10.2 Turbine Generator

The information in this section of the reference ABWR DCD, including all subsections, tables and figures, is incorporated by reference with the following departures and supplements.

**Figure 10.2-1 Turbine Stop Valve Closure Characteristic**

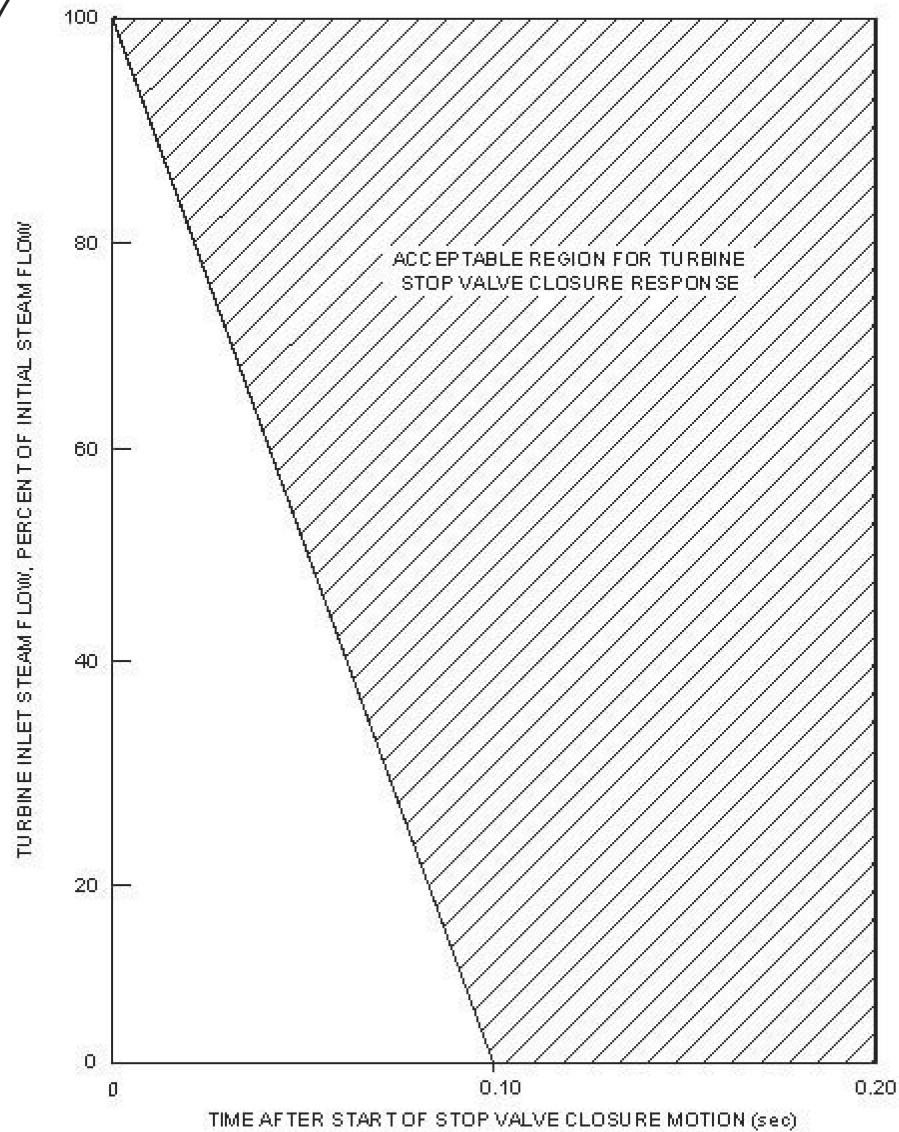
STD DEP Admin (Figure 10.2-1)

Figure 10.2-4 Generator Hydrogen and CO₂ System

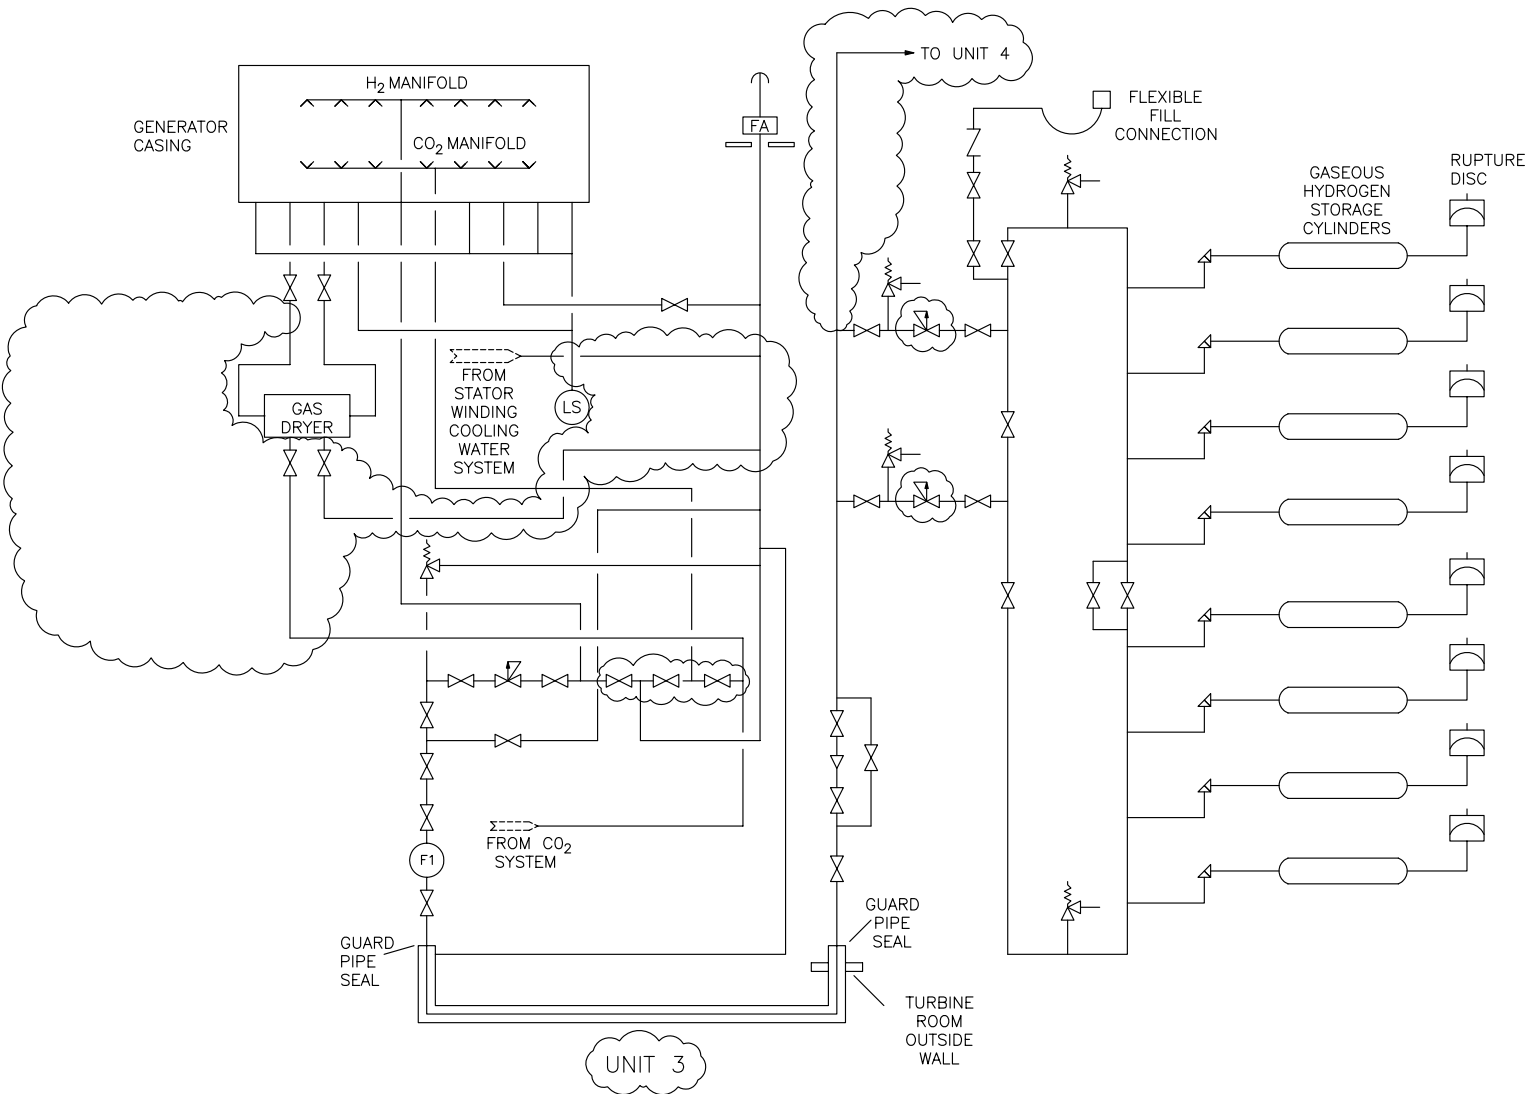
STP DEP 1.1-2 (Figure 10.2-4)

STP DEP 10.2-1 (Figure 10.2-4)

Bulk Hydrogen System—The bulk hydrogen and CO₂ system is illustrated on Figure 10.2-4. The hydrogen system is designed to provide the necessary flow and pressure at the main generator for purging carbon dioxide during startup and supply makeup hydrogen for generator leakage during normal operation.

Figure 10.2-5 Turbine Overspeed Trip System Functional Diagram

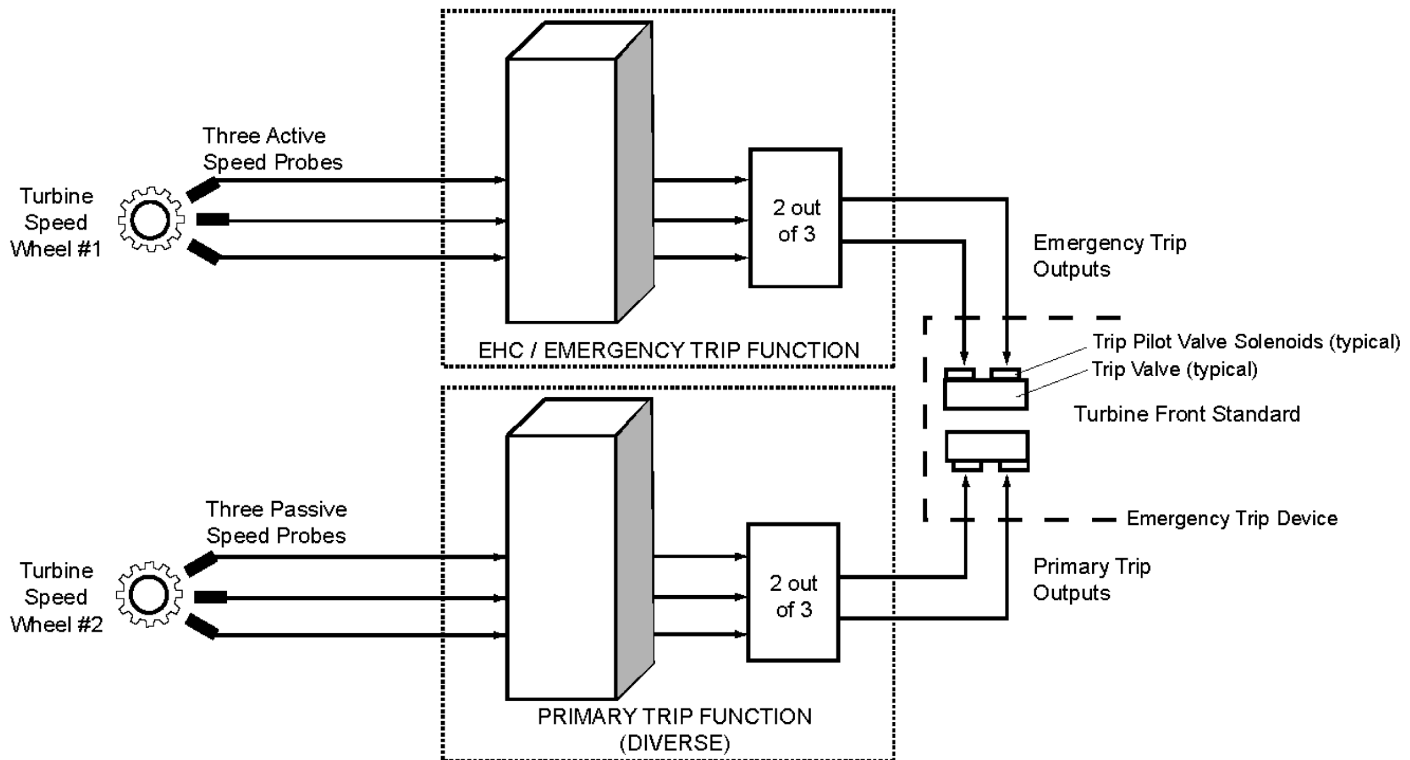
~~The overspeed trip system is electrical, redundant and consists of the Primary and Emergency overspeed trip functions. The primary trip function is independent and diverse from the emergency trip function as explained below (refer to Figure 10.2-5, Turbine Overspeed Trip System Functional Diagram). Reliability is achieved by using two sets of redundant speed sensing probes, which input to the independent Primary and Emergency Trip modules in the control system. For additional reliability, two-out-of-three logic is employed in both the Pprimary and Eemergency overspeed trip circuitry. EitherEach trip modulefunction can de-energize theits associated trip pilot valve solenoids of the electro-hydraulic Emergency Trip Device (ETD). The ETD is composed of two independent trip-solenoid valves, each with two normally energized fail-safe solenoids-operated pilot valves. For each trip valve, each trip pilot valve solenoid is powered from a separate power source. The solenoids-operated pilot valves de-energize in response to detection of an overspeed condition by the turbine speed control logic. De-energization of both solenoid-operated pilot valvestrip pilot valve solenoids is necessary to cause the spool in their respective trip-solenoid valve to reposition, which depressurizes the emergency trip fluid system, rapidly closing all steam inlet valves and indirectly closing the steam extraction nonreturn valves.~~
